City of Launceston Council Meeting Agenda

212 York Street, Launceston - Signs - Install a New Third-Party Illuminated Billboard Sign

FILE NO: DA0254/2024

AUTHOR: Rachael Huby, (Town Planner)

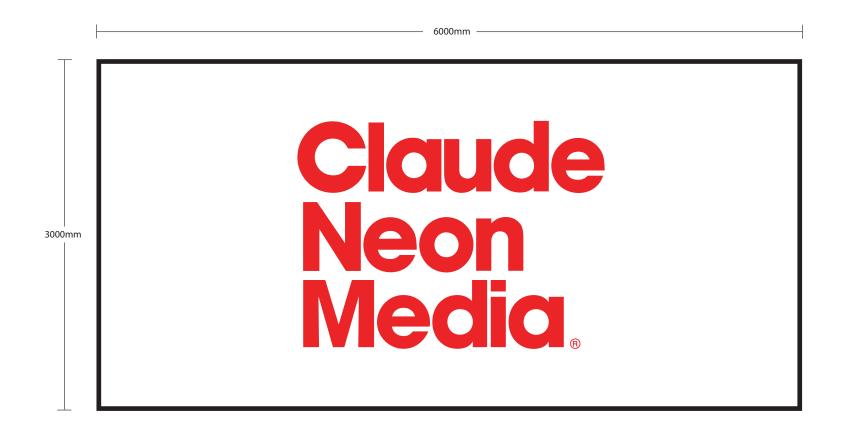
There is a difference between the desire to provide signage such as an advertising opportunity rather than the need for such messaging to promote local businesses. The applicant's consultant has argued that the sign is necessary to facilitate the prosperity of local businesses that rely upon the CBD volume for exposure, and that a sign of this nature would reduce the need for multiple signs in various locations with single static messaging.

A negative impact for pedestrians could be experienced when walking in a relatively busy area of the city in terms of the visual amenity. This is based on the proposed scale of the sign and the visual distraction that may result from the movement of the illuminated messaging emanating from the proposed sign. (e) any advice from a State authority

The application was referred to the Department of State Growth. No objection to the proposal was received.

Figure 1 – The site previously included a wall sign of similar dimensions in the same location (Source: Google Street View, August 2017)

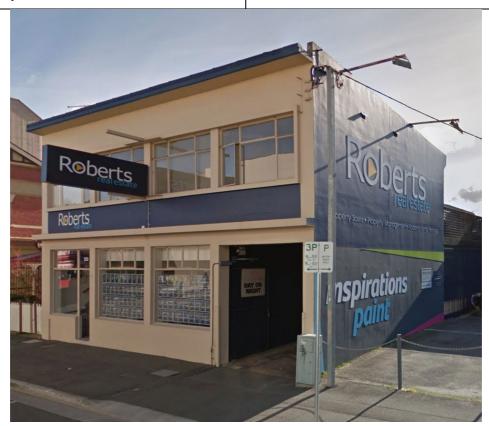
- c) (i) The proposed sign is 3m (h) x 6m(w) and is to be sited in the same location as a previous wall sign on the same wall (see Figure 1 below). The dimensions of the sign are similar to other signs in the area and not considered excessive for this location and on this building.
